RESPONSES TO COMMENTS on the Draft Environmental Impact Report

Biosolids Digester Facilities Project

CITY AND COUNTY OF SAN FRANCISCO
PLANNING DEPARTMENT
CASE NO. **2015-000644ENV**

BIOSOLIDS DIGESTER FACILITIES PROJECT RESPONSES TO COMMENTS on the Draft Environmental Impact Report

"2. Impacts of Other Project Components - Display Building

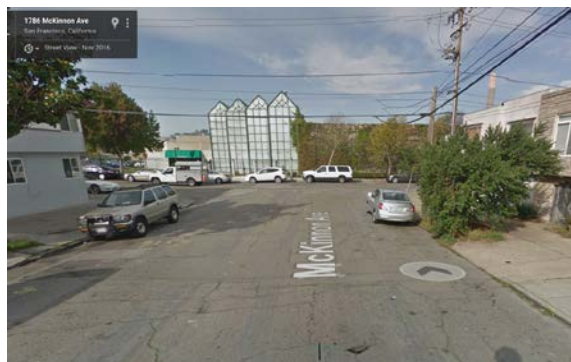
"The most prominent features of the greenhouses are four tall, narrow structures near the edge of the property on Phelps Street. As a separate action from the BDFP, the San Francisco Public Utilities Commission(SFPUC) plans to demolish the existing structures at the Southeast Greenhouses site (refer to Table 4.1-1 in Section 4.1). The site would be used for construction staging for the project if it becomes available prior to BDFP construction.'

"The smaller, yet taller, glassed in greenhouse 'facade' - THE DISPLAY BUILDING is a striking and important community marker at the intersection of Phelps and McKinnon Avenues. As community planners and advocates for improving the physical environment where we live, the potential for losing these smaller buildings (if contemplated in Phase 1) seems antithetical to the goals we've set for ourselves in lifting this place in Bayview.

2. Impacts of Other Project Components - **Display Building**

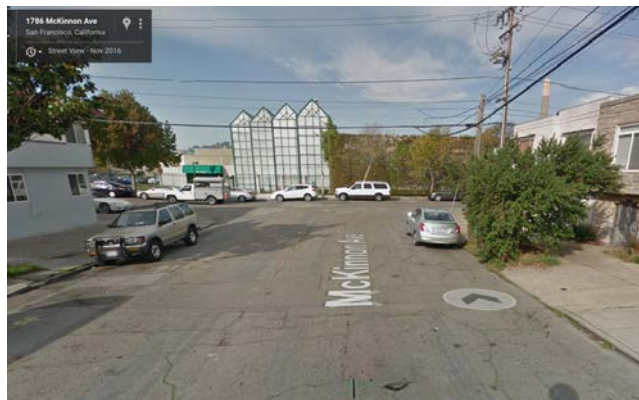
'The most prominent features of the greenhouses are four tall, narrow structures near the edge of the property on Phelps Street. As a separate action from the BDFP, the San Francisco Public Utilities Commission(SFPUC) plans to demolish the existing structures at the Southeast Greenhouses site (refer to Table 4.1-1 in Section 4.1). The site would be used for construction staging for the project if it becomes available prior to BDFP construction.'

SFPUC Biosolids Digester Facilities
Figure 2-15
 Construction Haul Routes

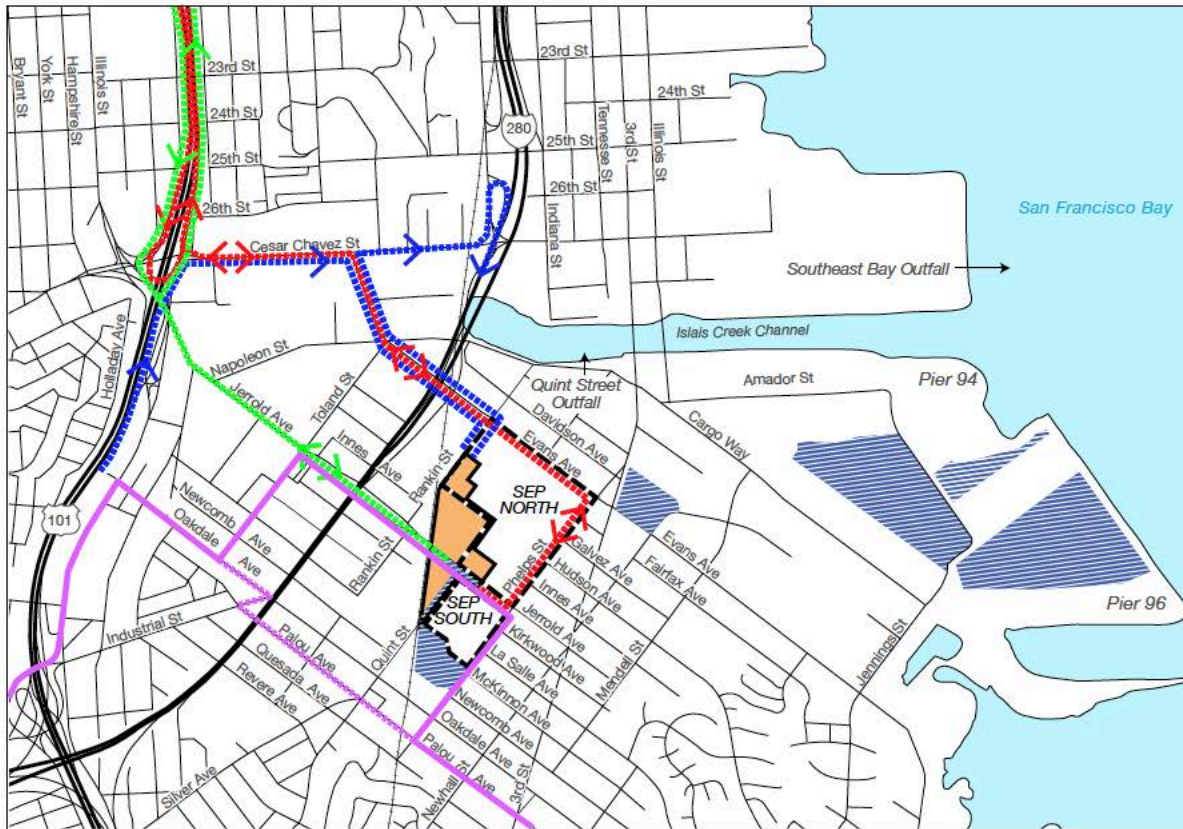
“BRITE calls on the SFPUC to define a construction and staging plan that does not call for Jerrold to close. Consider using existing road infrastructure within the SEP boundaries; instead of performing roadwork during Phase 1 to transform the traffic patterns through the produce market, use that time and funding to make roadway improvements within the SEP boundary to handle the construction and hazardous material traffic currently targeted for Jerrold.” (Steven Tiell, Bayview Residents Improving Their Environment, Letter, May 30, 2017, and Email, May 31, 2017)

“Yet there are better alternatives available for traffic. Rather than sending trucks and buses down such a narrow street as Phelps Street, negatively impacting the small businesses that have already been negatively impacted for decades by the plant, traffic should be directed from Evans to Mendell to Jerrold or from Evans to Rankin directly into the plant.

“I encourage you to investigate better alternatives than sending all of this traffic on Phelps Street from Evans to Jerrold including routing traffic from Evans to Mendell Street to Jerrold or along Evans to Rankin and directly into the plant. In so doing the burden on small businesses in the Bayview would be significantly lessened, bicycle riders will be protected, and San Franciscans patronizing the businesses on Phelps Street will be safer.” (Mark Klaiman, PetCamp, Email, June 19, 2017)

The effects of the temporary closure of this segment of Jerrold Avenue and the effects of BDFP construction activities on travel on Phelps Street are described in Impact TR-1 (Draft EIR pages 4.6-35 to 4.6-46) and were determined to be less than significant. Draft EIR Figures 2-14 and 2-15 (pages 2-57 and 2-60) present the construction staging access plan for the project site and

Regarding the potential for dust from off-site transport, as shown on Draft EIR Figure 2-15 (Draft EIR page 2-60), only incoming (unloaded) trucks would use Jerrold Avenue through the produce market. Outgoing (loaded) trucks would use Rankin Street, Evans Avenue, and Cesar Chavez Street for access to either U.S. Highway 101 (Highway 101) or Interstate 280, and would not pass through the produce market. Further, in accordance with the Dust Control Ordinance, the amount of soil in hauling trucks would be limited to the size of the truck bed and walls, and trucks hauling loose materials (e.g., soil and sand) would be covered with a tarpaulin or other effective cover. With implementation of these measures, there would be no significant dust generation along the haul routes associated with the hauling of waste materials from the BDFP site.

SFPUC Biosolids Digester Facilities
Figure 2-15
 Construction Haul Routes

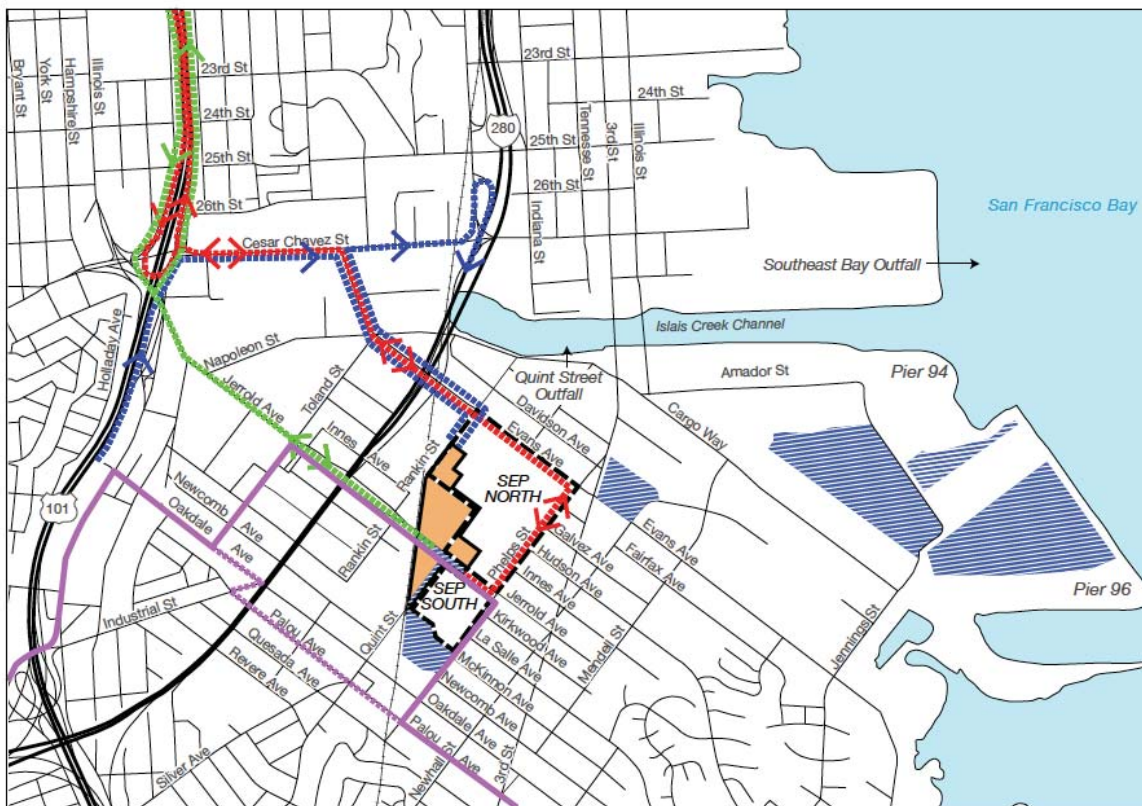
3. Reconsideration of the temporary relocation of Muni 23 Monterey Bus line. SFPUC, with SFMTA as lead agency, to consider the cumulative impact of the Jerrold Street closure, the streetscape improvement project on Palou Avenue, the narrowing of Evans Avenue, and the heavily impacted Oakdale Avenue arterial due to the above concurrent projects.

SAN FRANCISCO WHOLESALE PRODUCE MARKET
AND NEIGHBORING PROJECTS

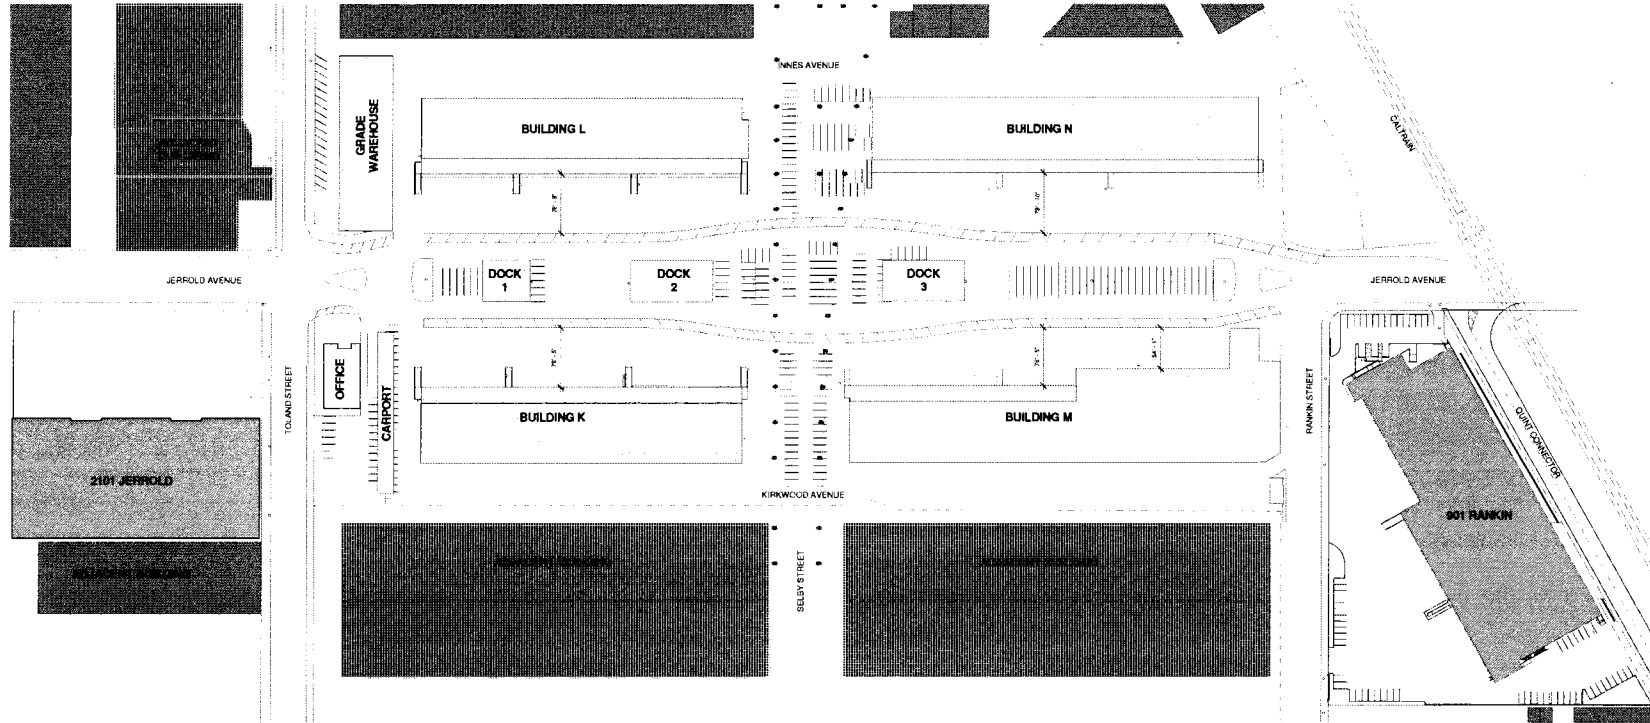
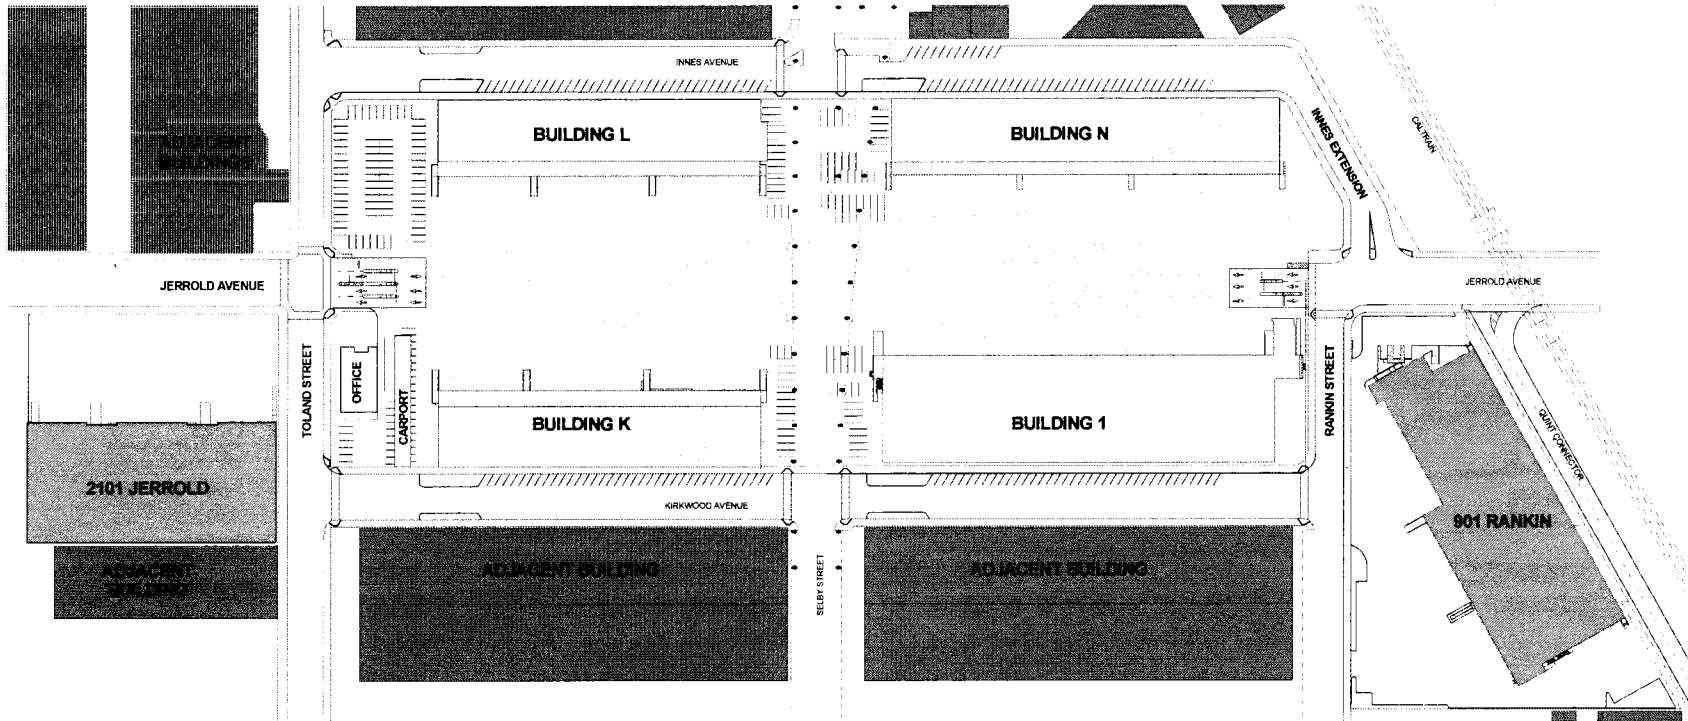
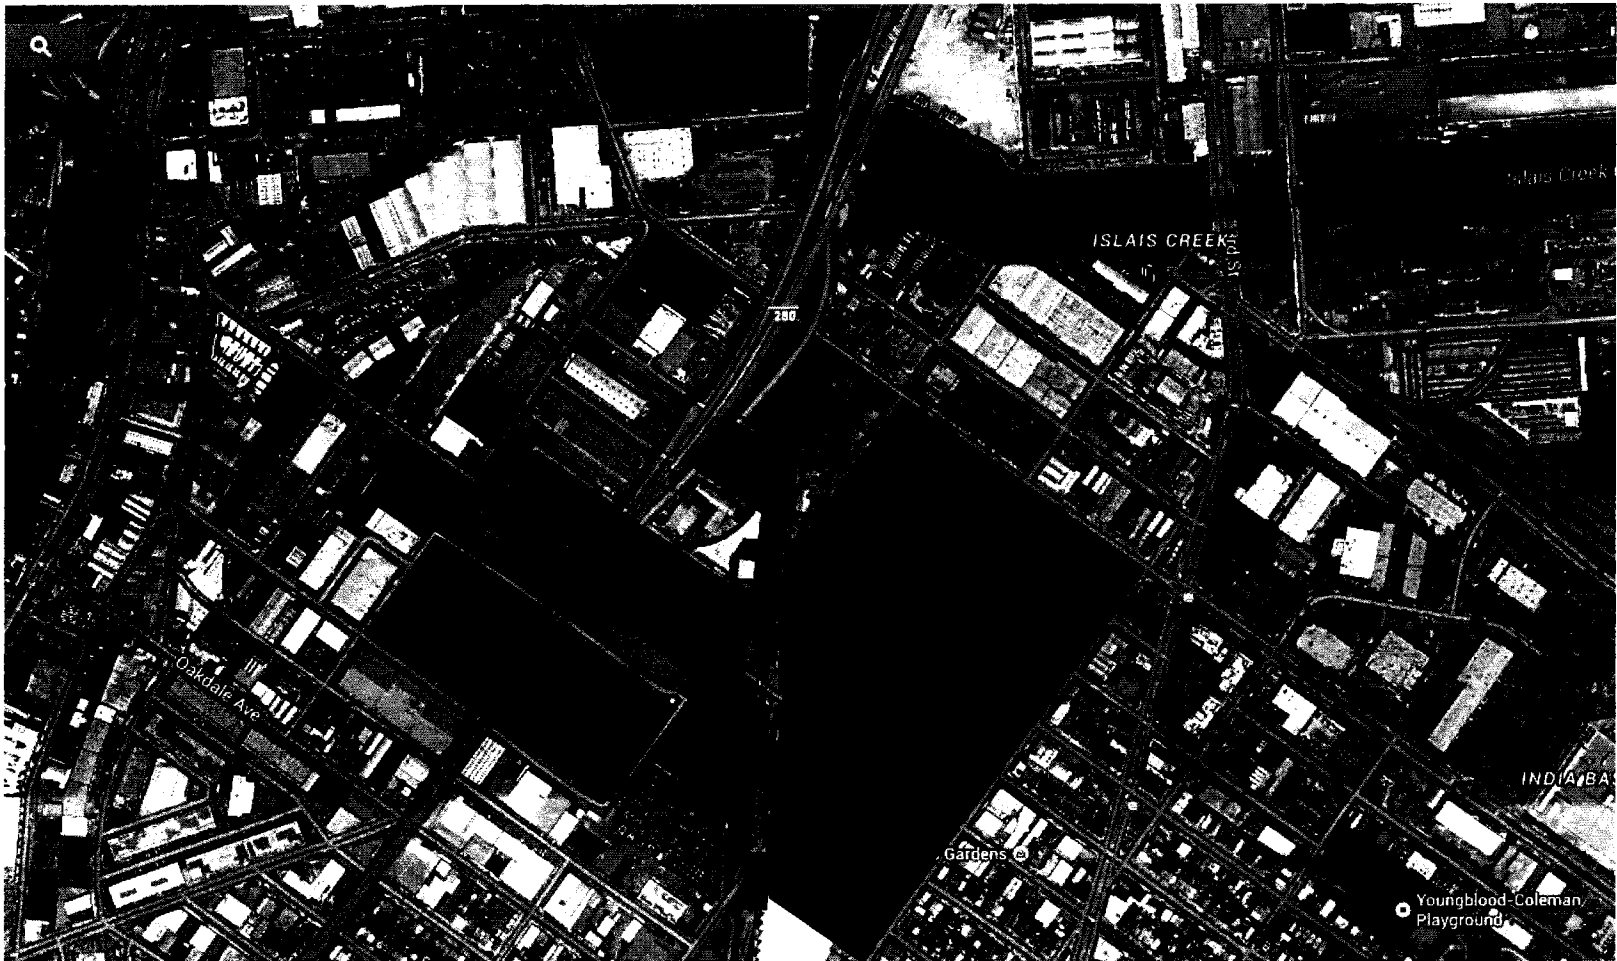
O-SFWPM-1.4

The produce market also requests that the design of its planned improvements to Innes Avenue be coordinated with the BDFP, and included in the BDFP Draft EIR project description. However, as presented on Figure 2-12 (Draft EIR page 2-48), upon completion of the BDFP construction, all BDFP operational trucks (including chemical delivery, yellow grease loading, and biosolids trucks) would use Evans Avenue for access to the water pollution control plant, and would therefore not travel on Jerrold Avenue or the new roadways required to be constructed by the produce market. The produce market Innes Avenue improvements should not be part of the BDFP project description and no change to the Draft EIR is necessary. Regardless, the SFPUC will continue to coordinate with the produce market on the two projects.
